FCPS NEW MIDDLE SCHOOL – POLO CLUB KDE BG # 21-176 FCPS BID # 20-21 JRA Project No. 202078 Fayette County Public Schools Lexington, Kentucky

ADDENDUM ITEMS:

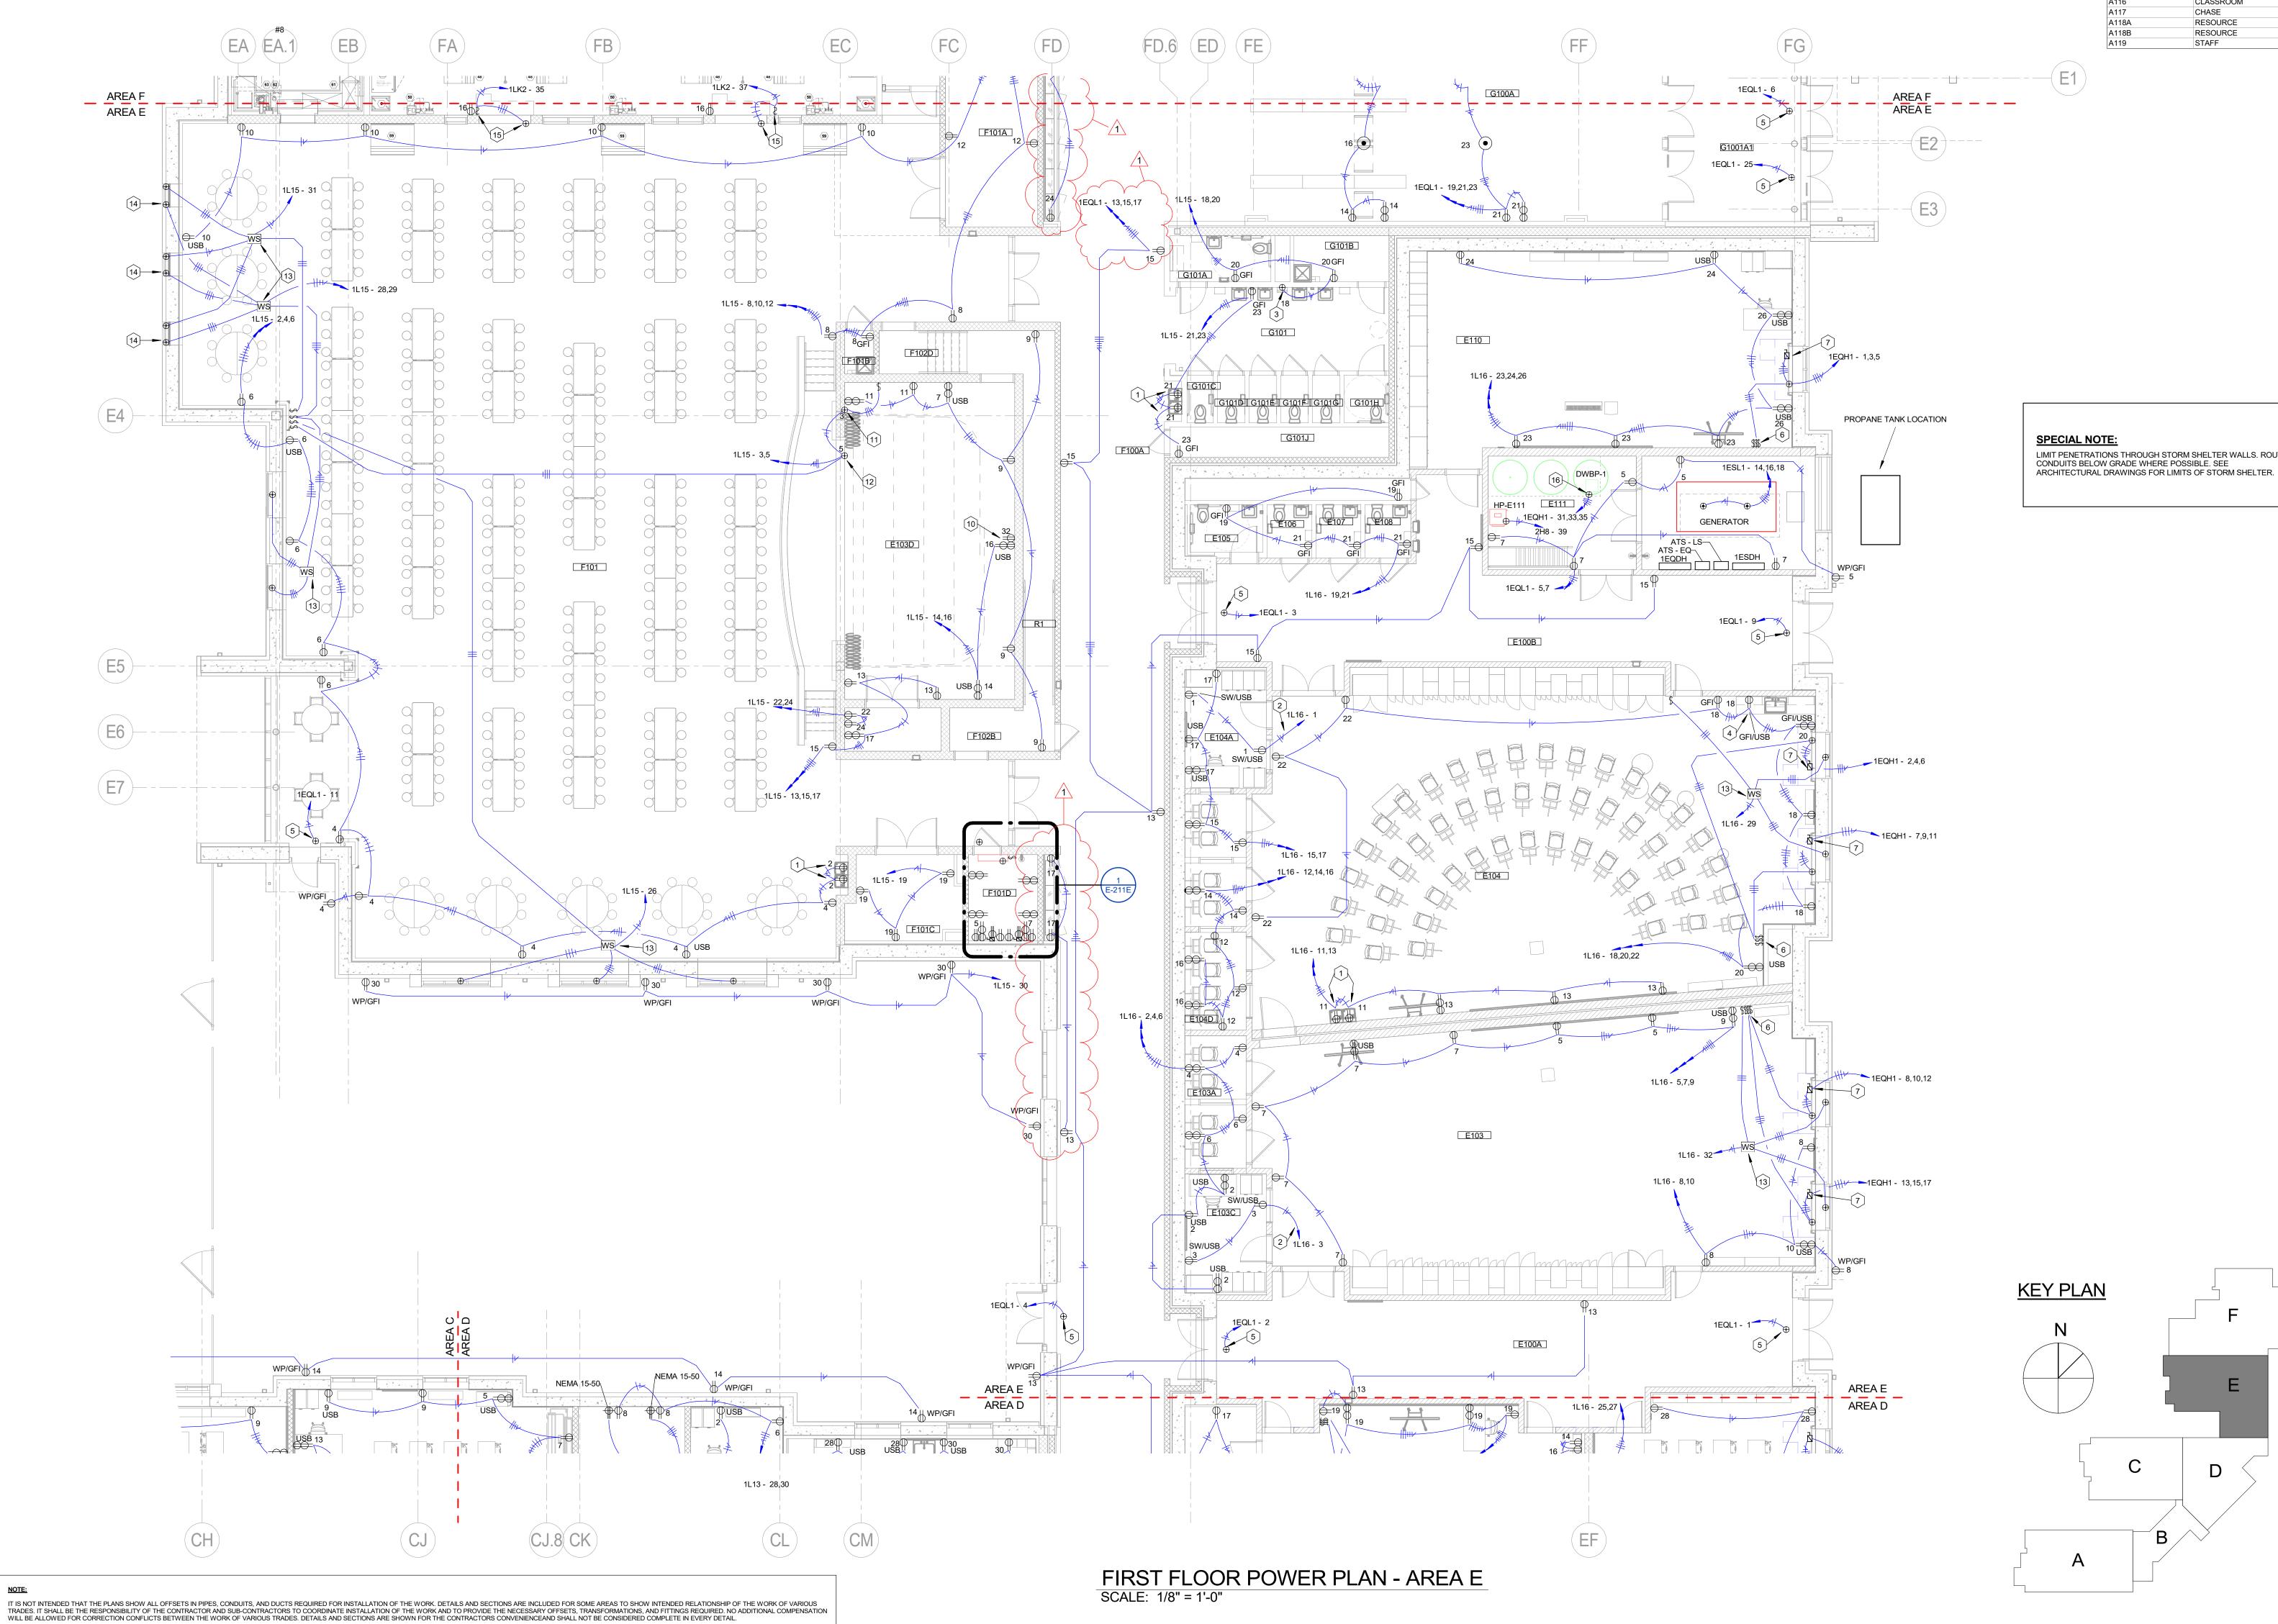
Refer to sheet E-211B – Add power to trophy cases.

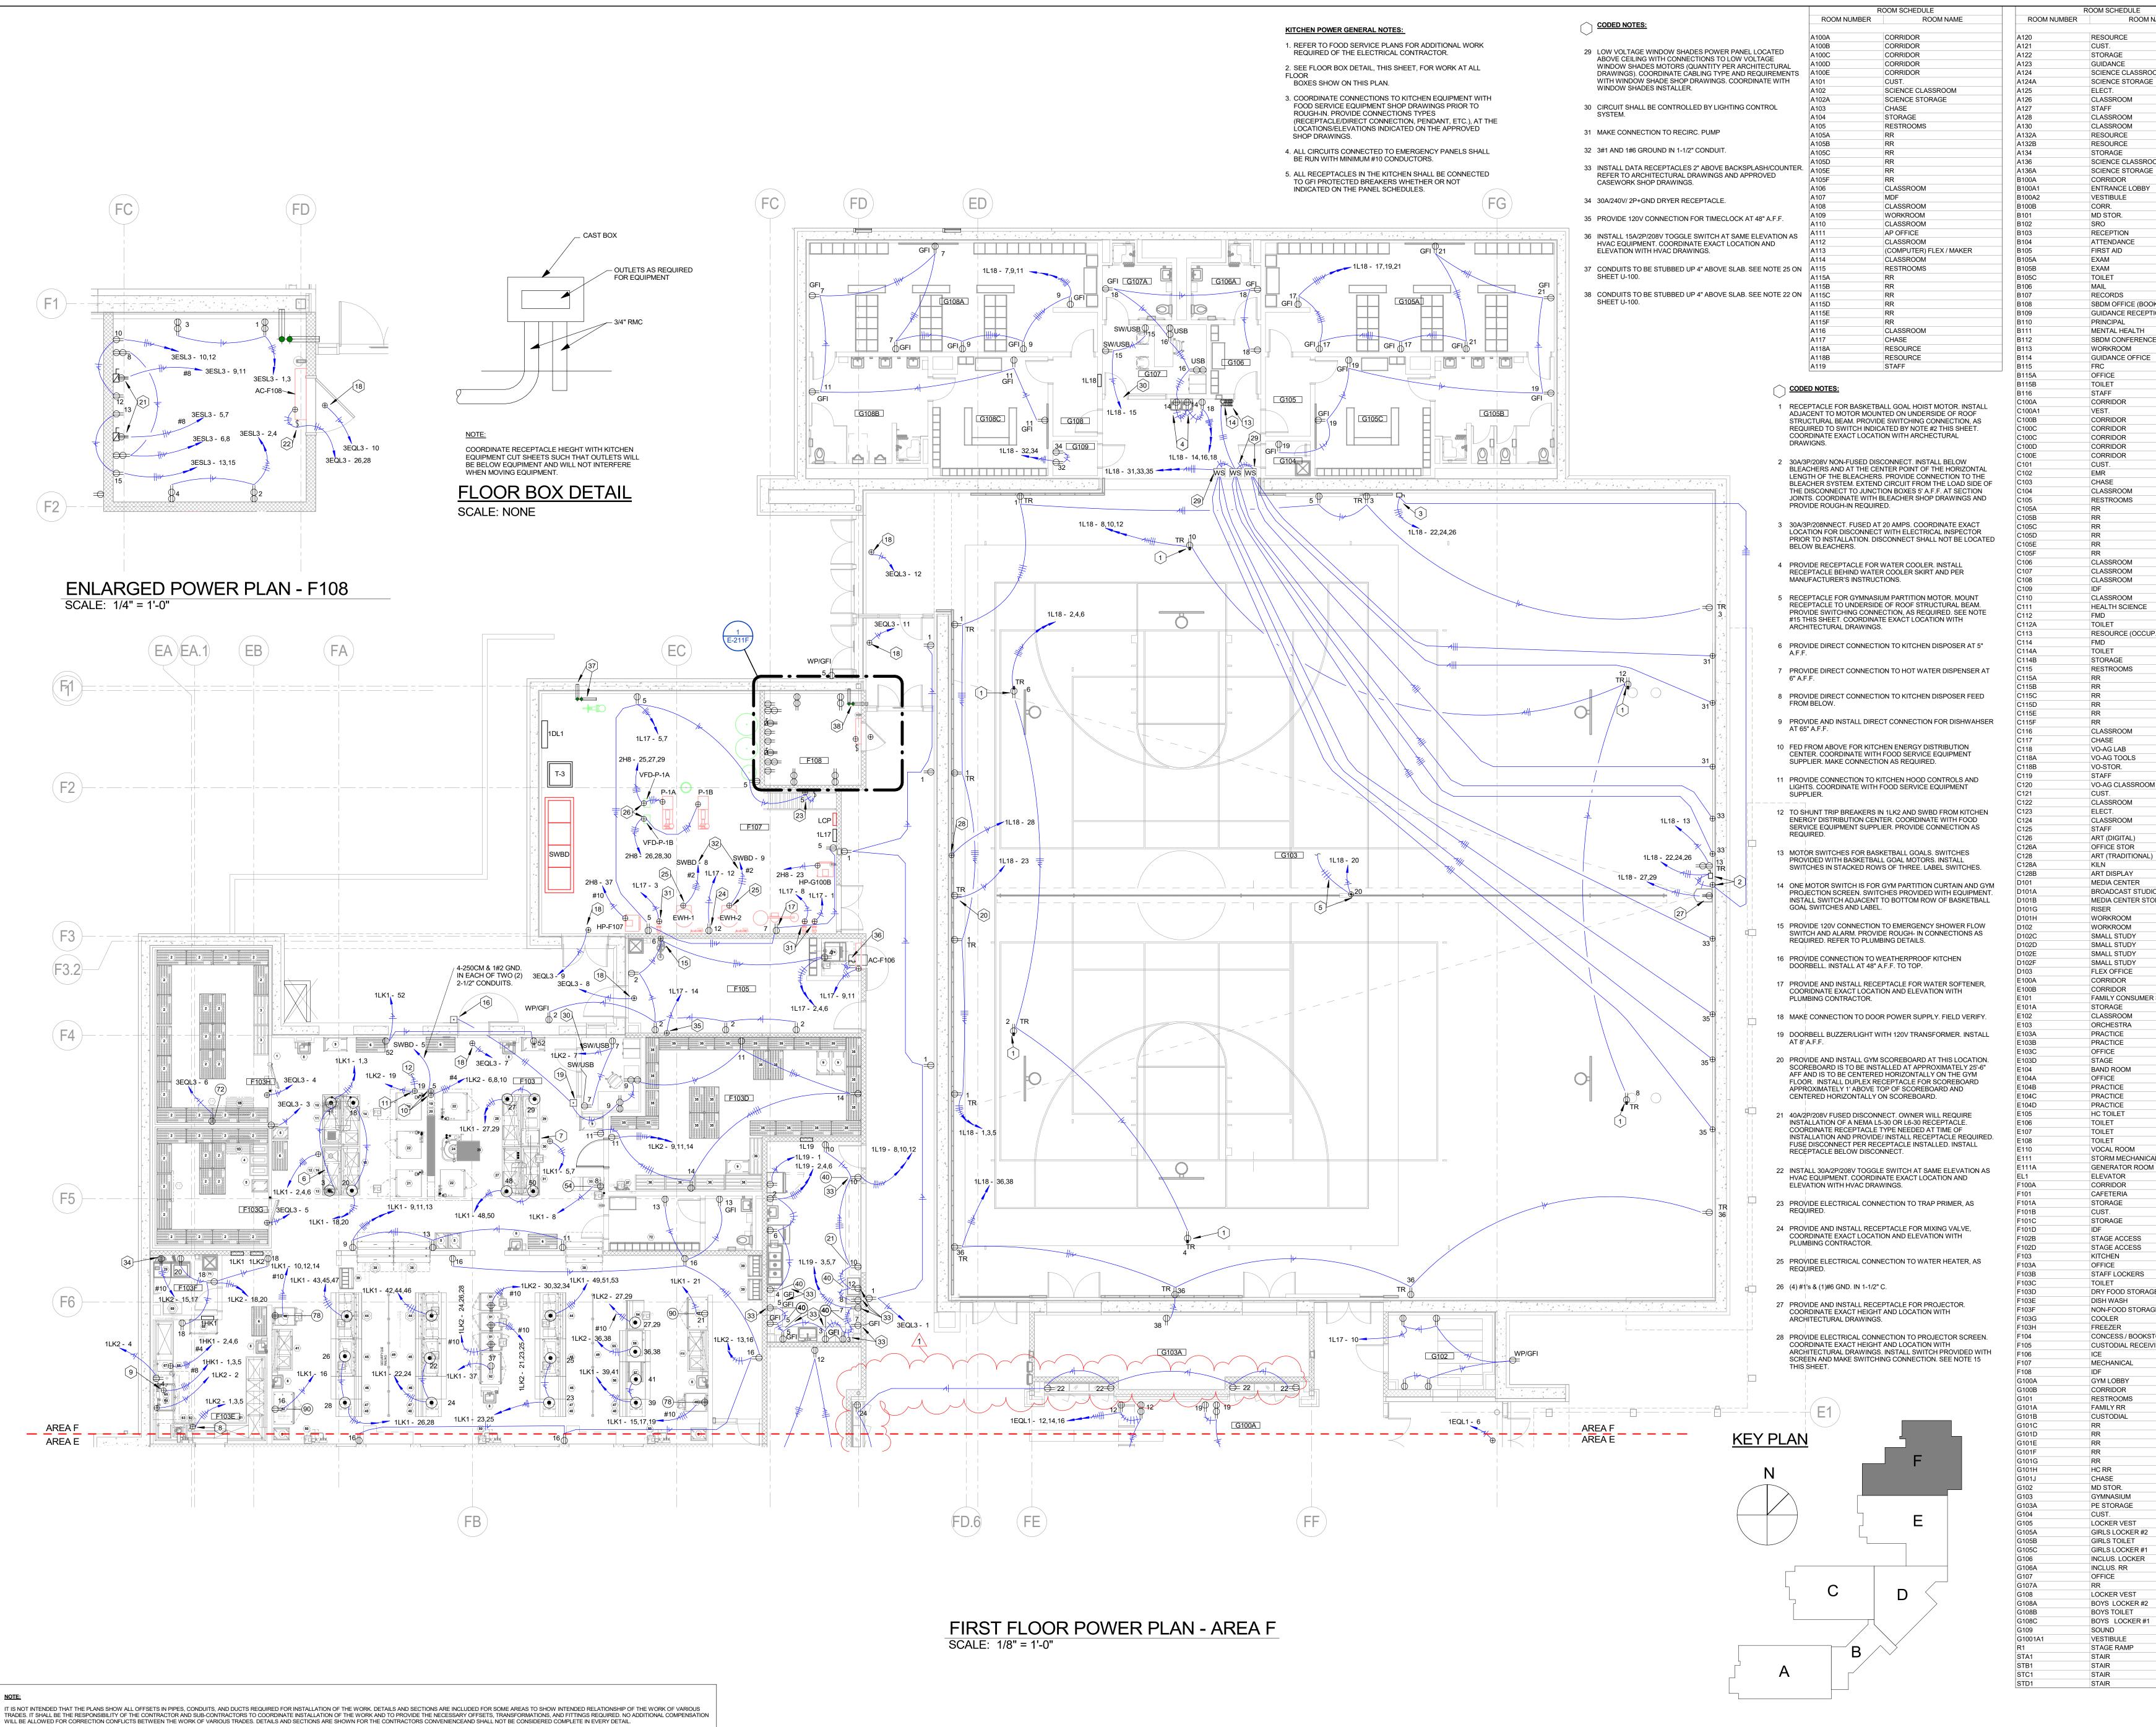
Refer to sheet E-211F – Add power to trophy cases.

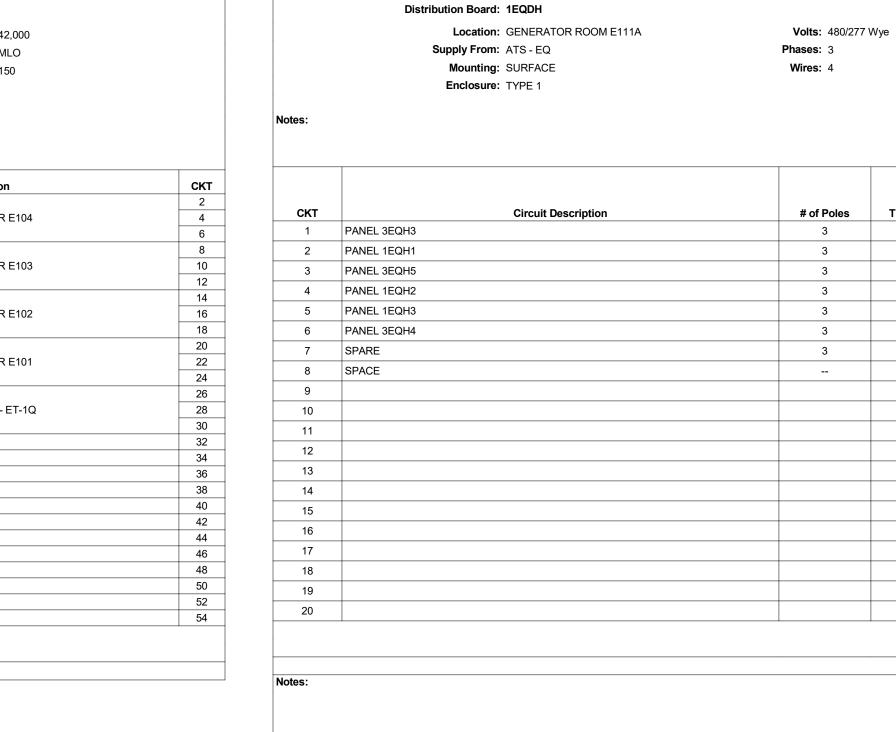
Refer to sheets E-410 and E-411 – Revise panel schedules.
